DIAGNOSTIC DESIGN

MAST Installation

Total Assembled View

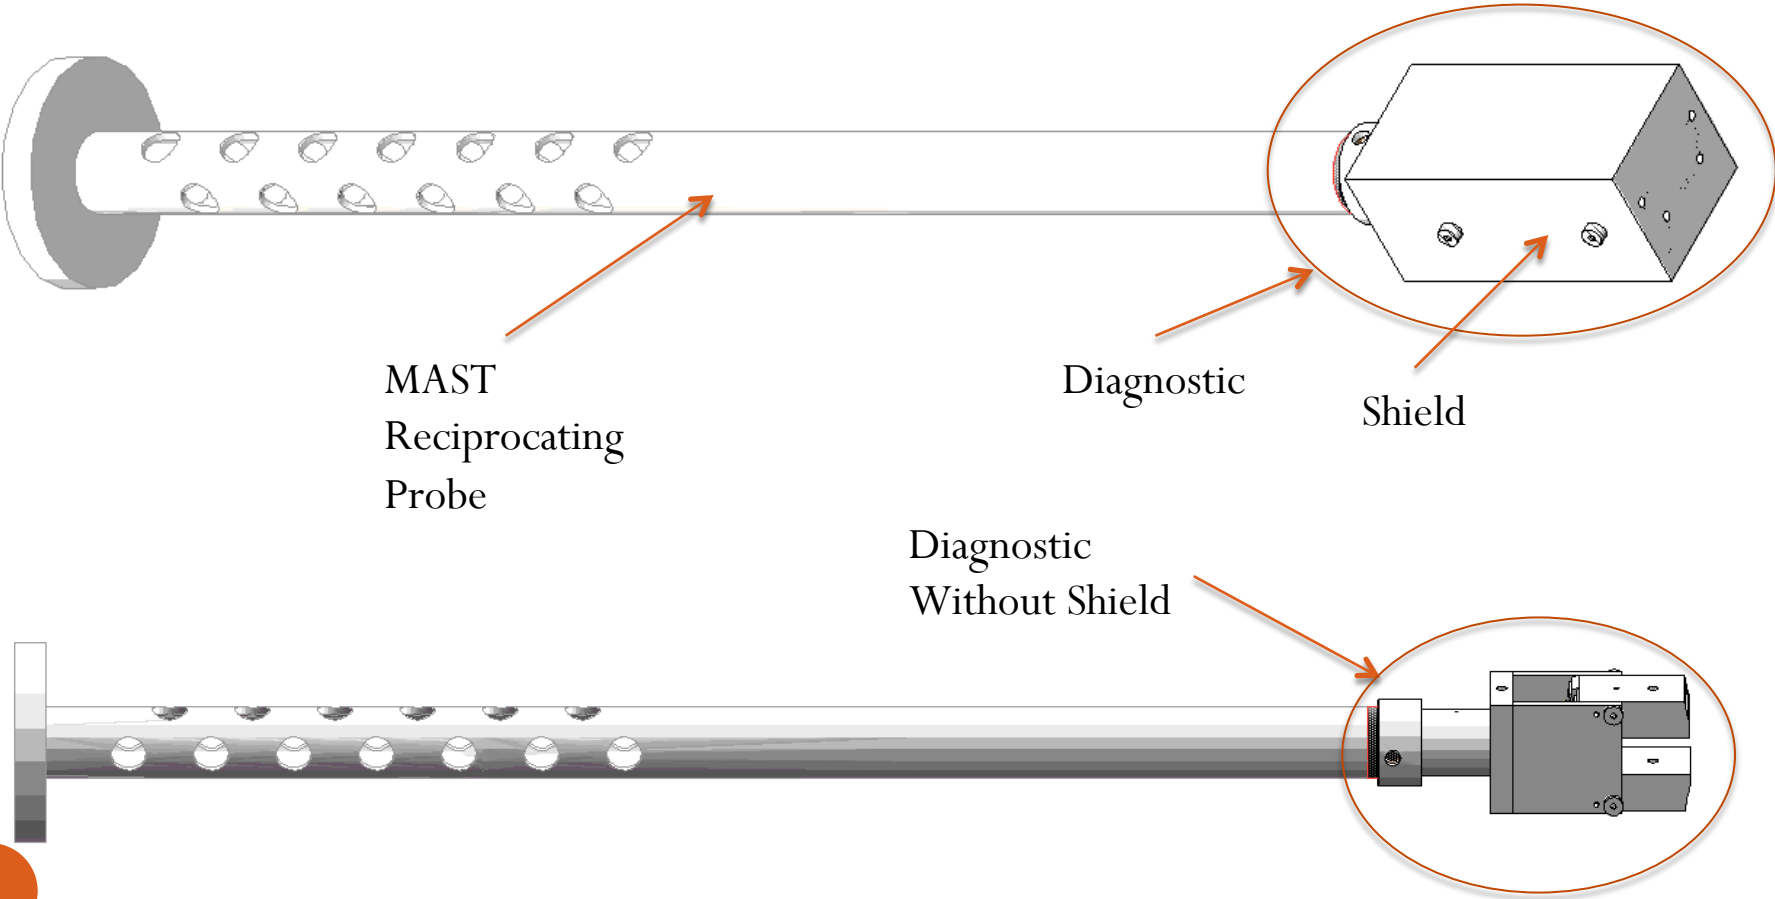
COMMENT 9

ISSUE: MAST DESIGN REGULATIONS REGARDING DIAGNOSTICS

IDEA: CONTACT MAST COLLEAGUES

Total Exploded View

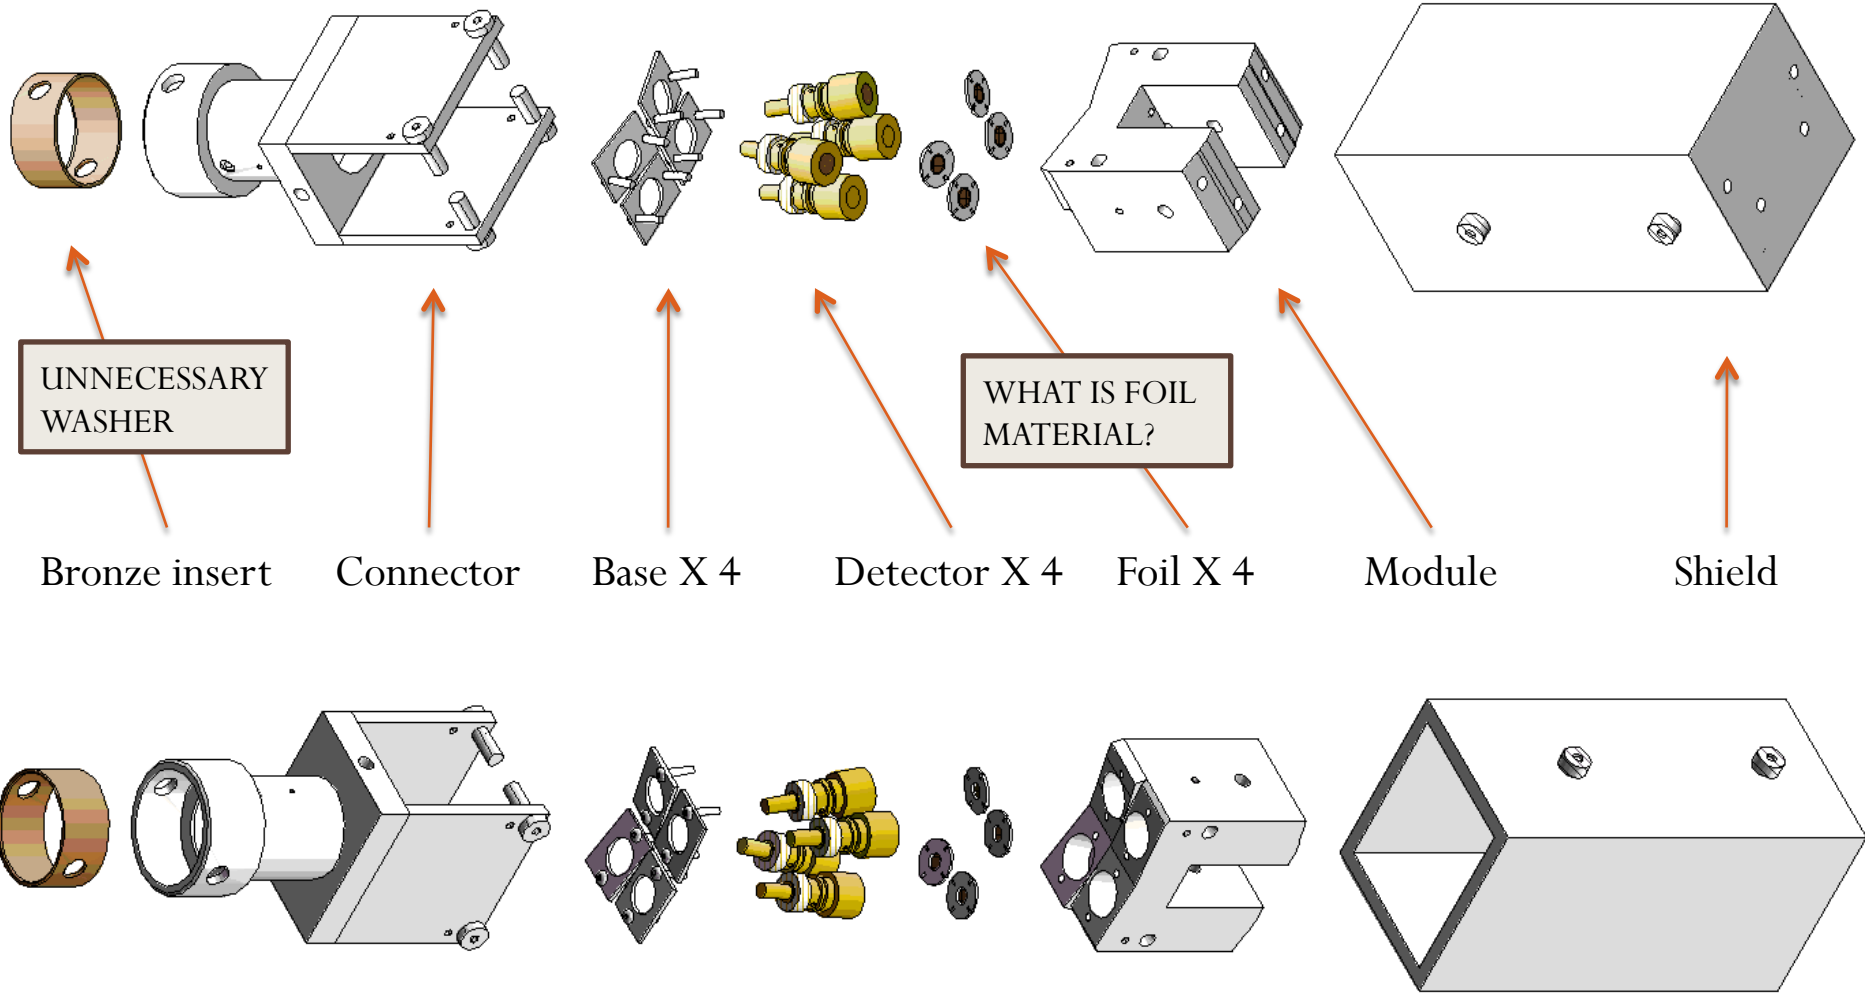
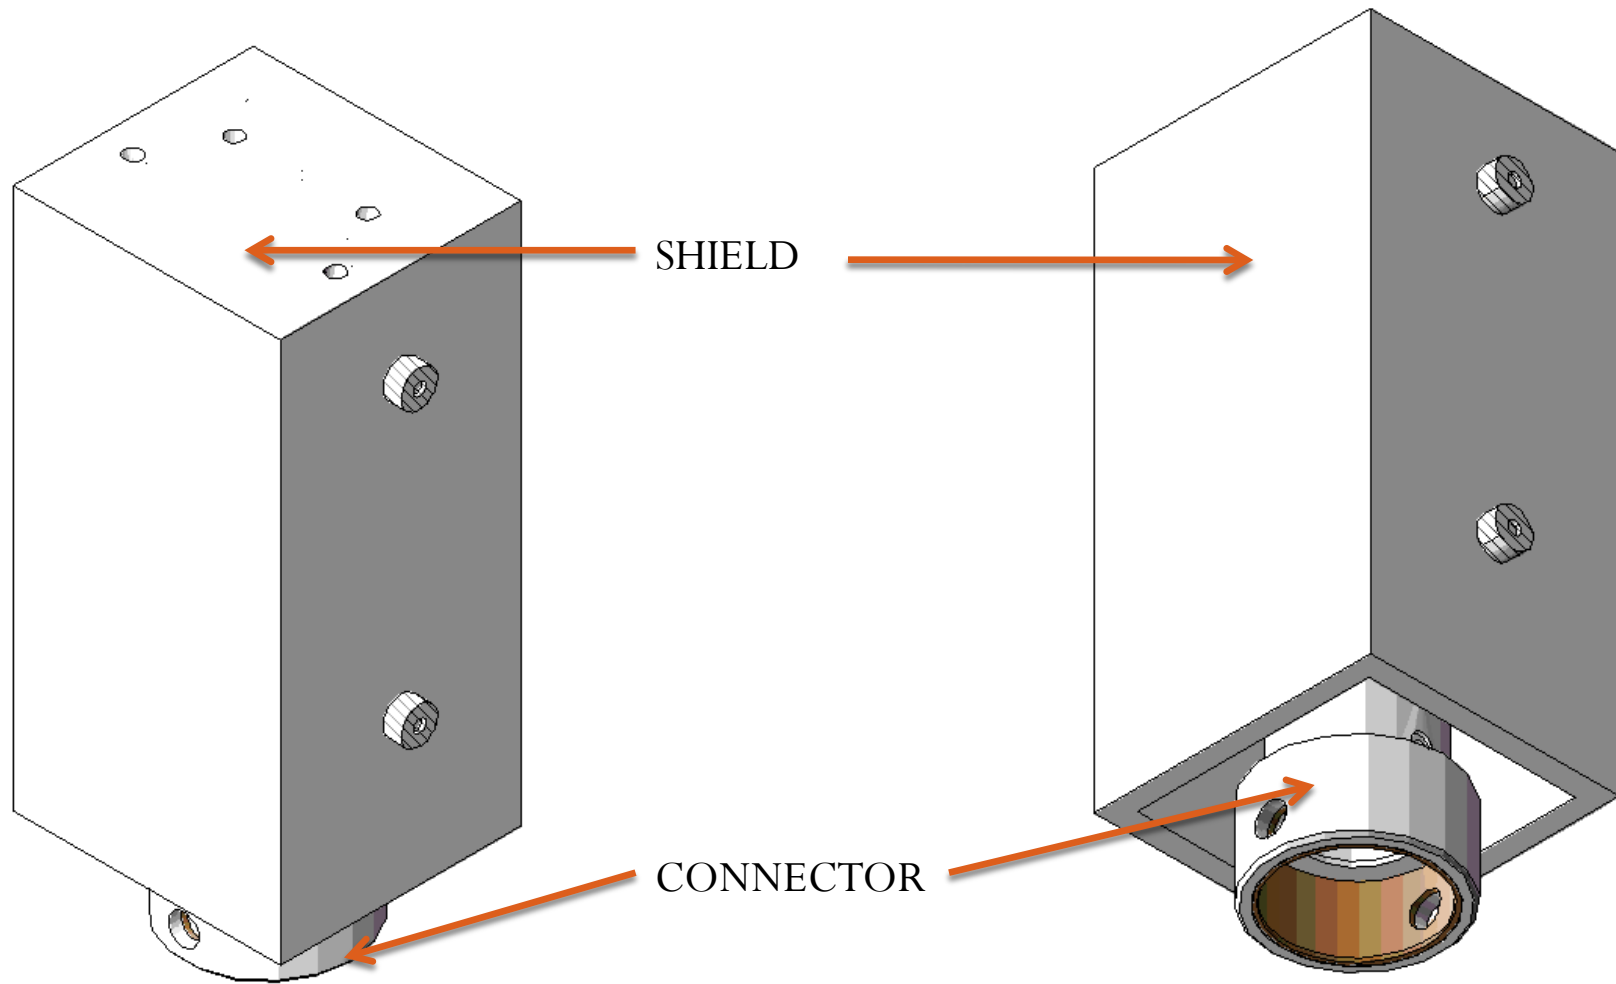
UNNECESSARY
WASHER

WHAT IS FOIL
MATERIAL?

Total Assembled Dimension

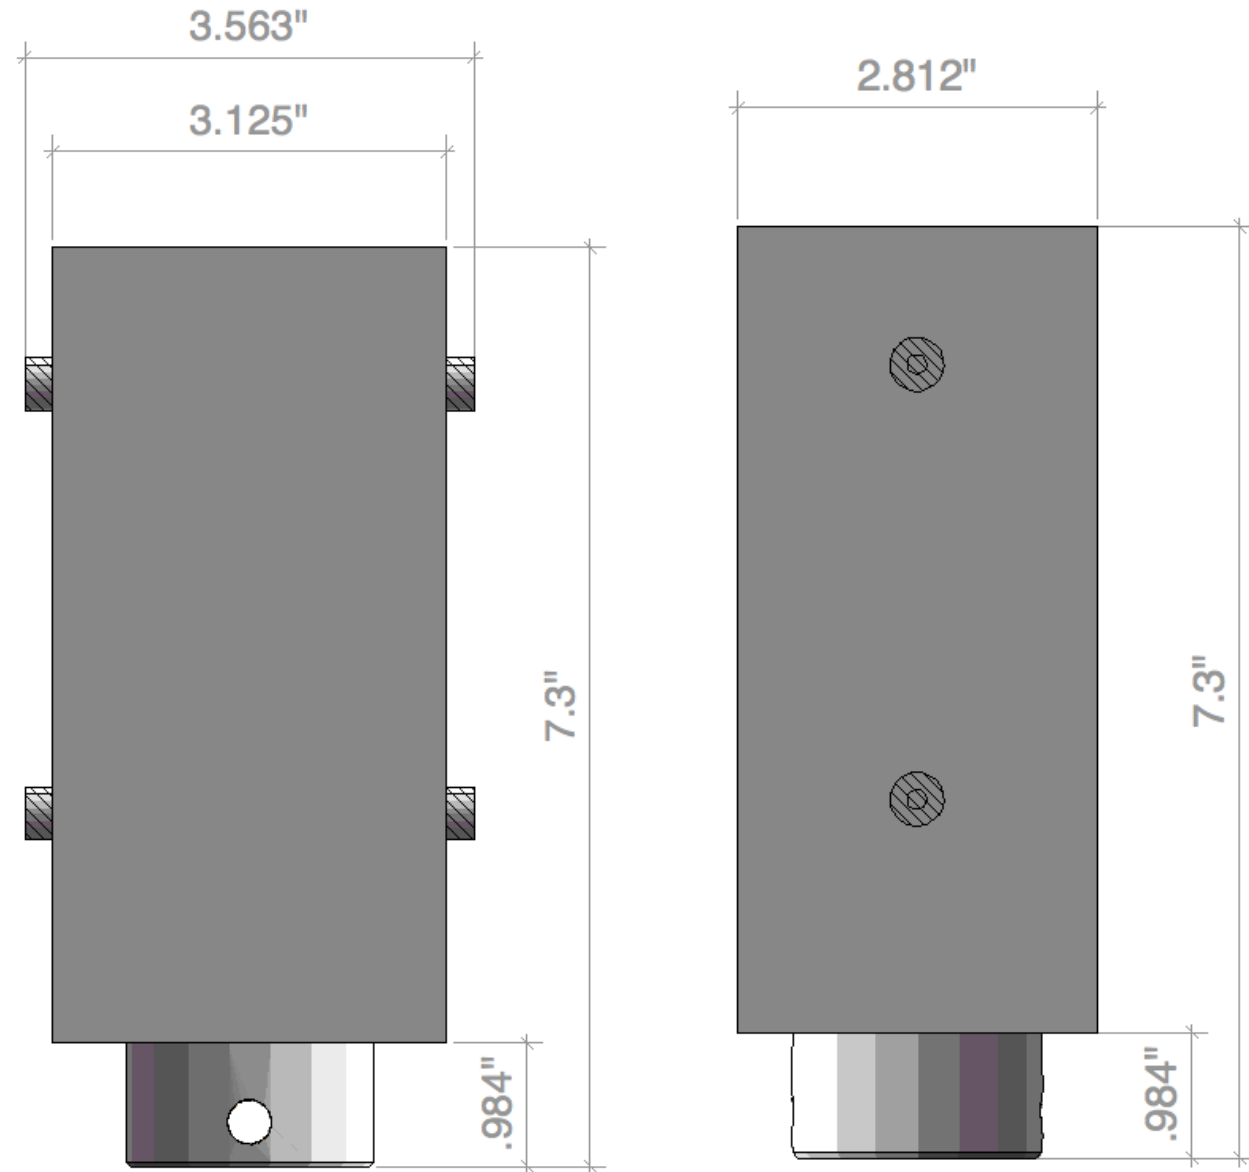
COMMENT 1
ISSUE: POSSIBLE
HARDWARE
COMPLICATIONS AT
MAST, FOR EXAMPLE
NEEDING TO REPLACE A
MACHINE SCREW
IDEA: CHANGE ALL
MEASUREMENTS AND
HARDWARE TO METRIC

Module Cross Section

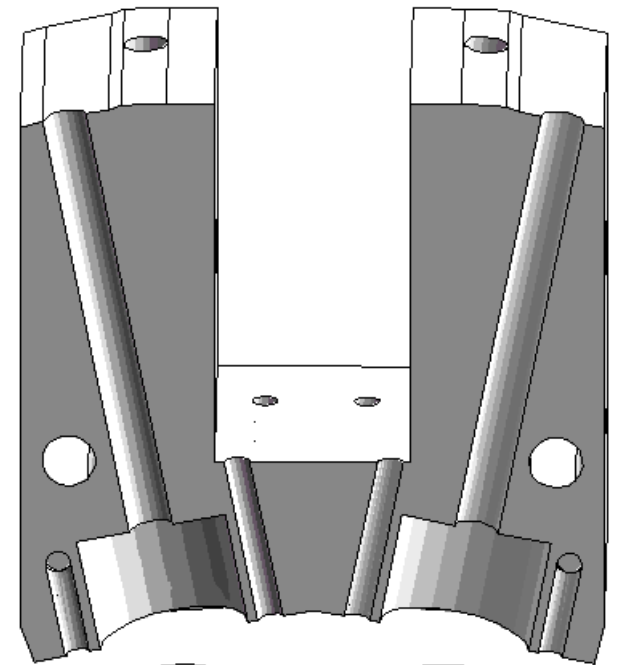
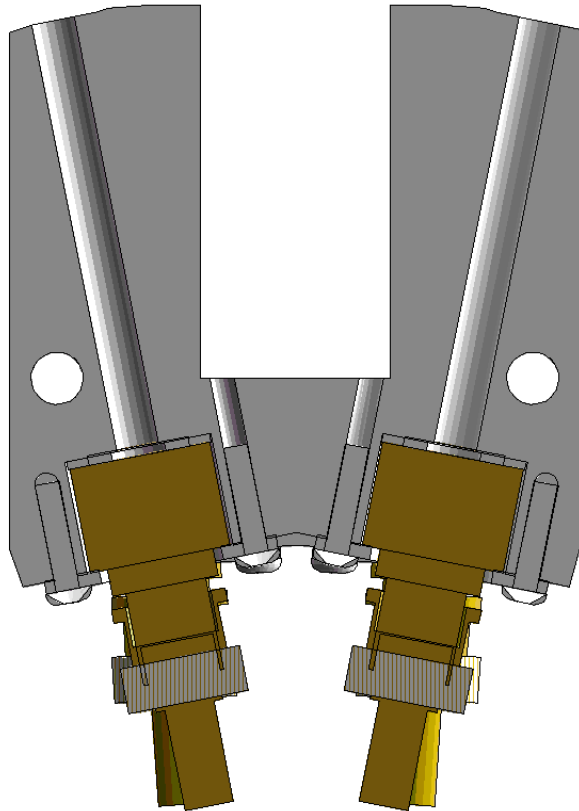
COMMENT 8

ISSUE: DETECTOR INSULATION

IDEA: USE UHV (ULTRA HIGH VACUUM) APPROVED INSULATOR SUCH AS PEEK, VESPEL, MAYCOR, BN CERAMIC, OR TEFLON TO CREATE A THIN SLEEVE AROUND INDIVIDUAL DETECTORS; CONTACT MAST COLLEAGUES FOR MATERIAL APPROVAL

USE PEEK 100 TO INSULATE COMPONENTS NOT EXPOSED TO PLASMA;
DETECTOR INSULATION ENCOURAGED

Shield

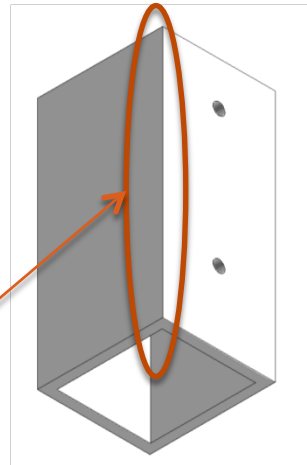
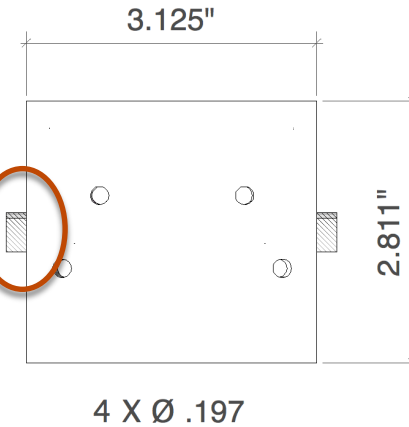
COMMENT 5

ISSUE: SHARP EDGES ON SHIELD
IDEA: ROUND ALL EDGES ON SHIELD
(INCREASE SHIELD THICKNESS SO
EDGES ARE STILL .25" IN THICKNESS)

COMMENT 6

ISSUE: IS ROUNDED RECTANGULAR SHAPE OKAY
FOR SHIELD, OR DOES MAST PREFER
CYLINDRICAL?
IDEA: CONTACT MAST COLLEAGUES

COMMENT 4

ISSUE: SCREWS NOT FLUSH WITH SURFACE
IDEA: COUNTERSINK SCREWS FOR SHIELD

COMMENT 3

ISSUE: SECURE SCREWS TO BN SHIELD
IDEA: SPOTWELD SHIMSTOCK STRAP FROM
SCREW HEAD TO CONNECTOR OR USE
APPROVED UHV CERAMIC ADHESIVE

EITHER SHAPE IS FINE; CYLINDRICAL
CHEAPER TO MANUFACTURE

Alternate Washer to Change Collimator Size

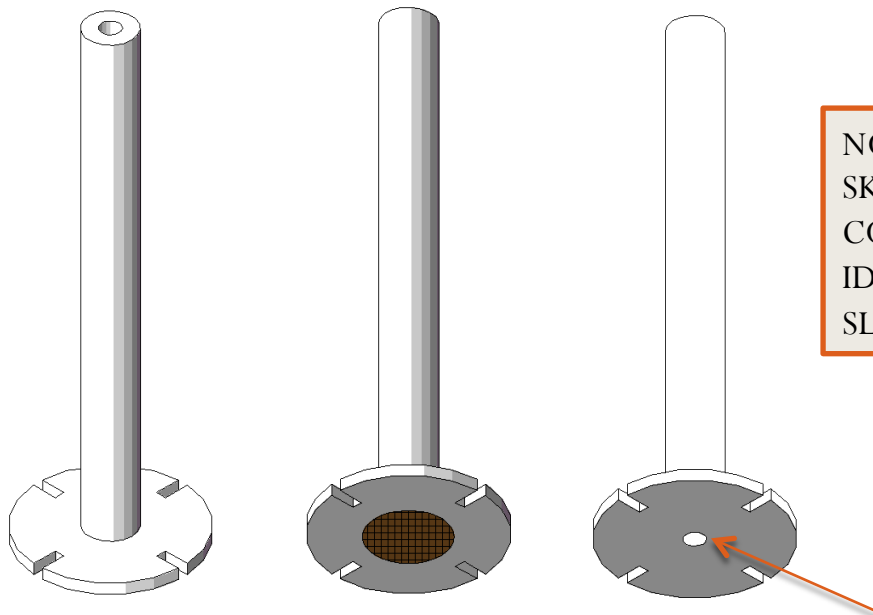
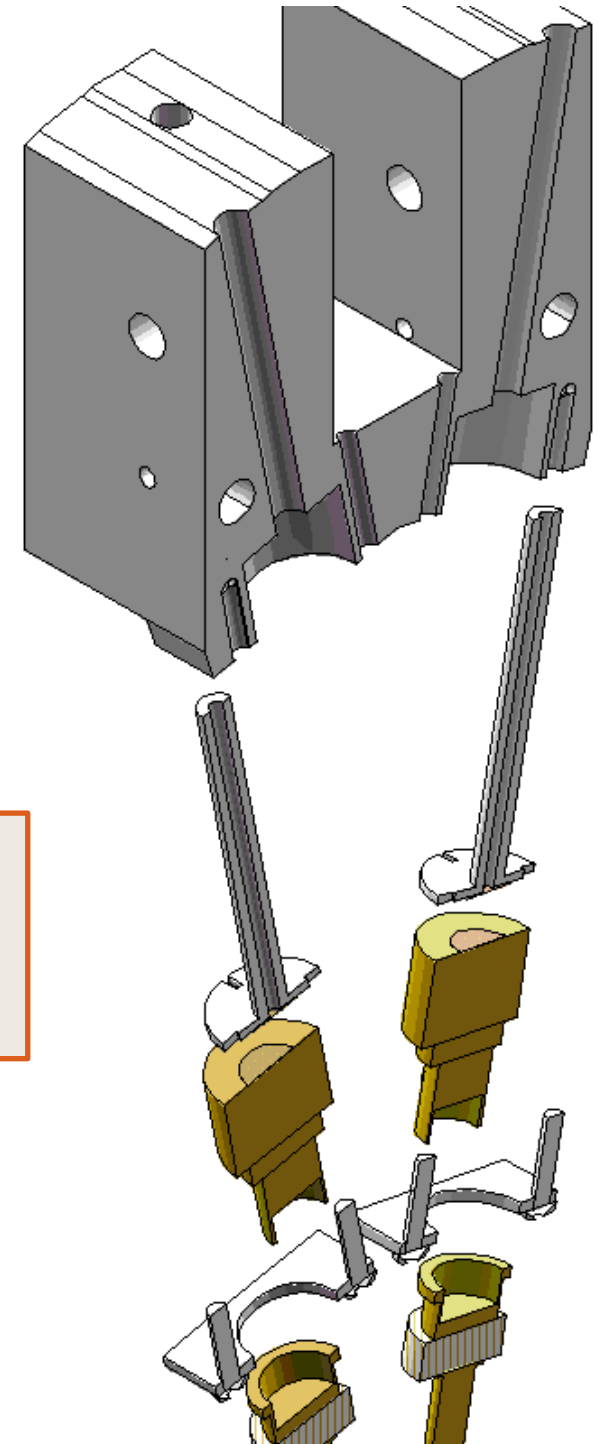
COMMENT 10

ISSUE: NEED ANOTHER WAY TO CHANGE COLLIMATOR SIZE, PREFERABLY ONLY REQUIRING THE REMOVAL OF THE BN SHIELD (UNLIKE METHOD SHOWN HERE)

IDEA: INSERT NEW COLLIMATOR CYLINDER THROUGH TOP OF MODULE AND PROVIDE FOR ATTACHMENT

SKETCH OF IDEA FOR
COMMENT 10

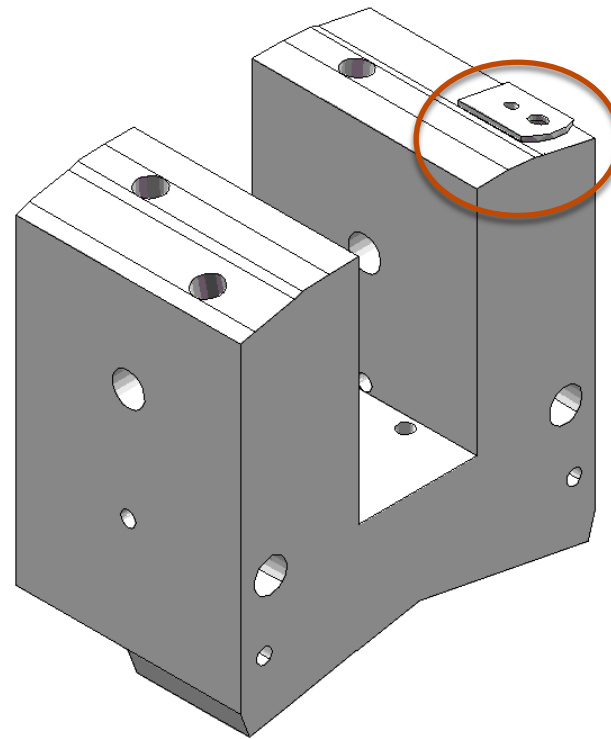
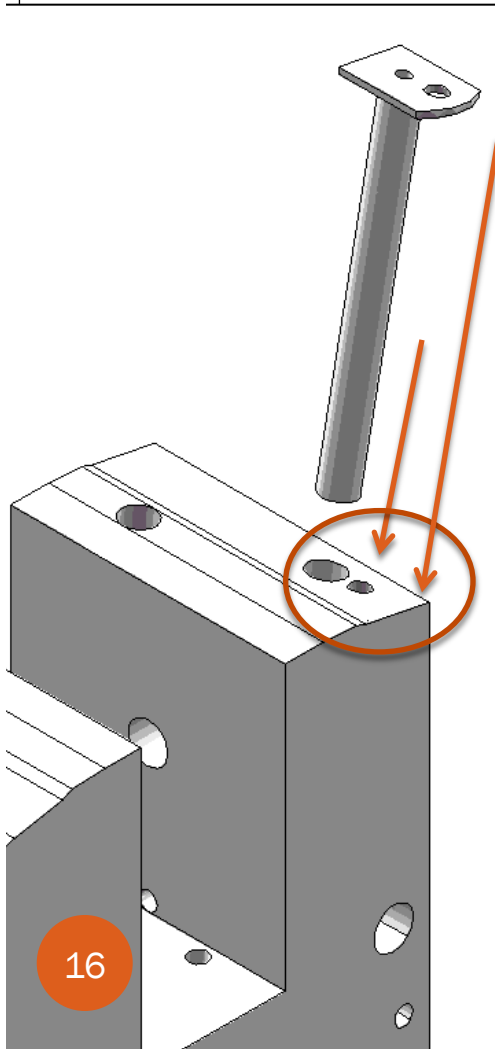
CONSIDER PLACING
SMALL LIP AT
BOTTOM OF SHAFT
TO SECURE IT MORE
SECURELY
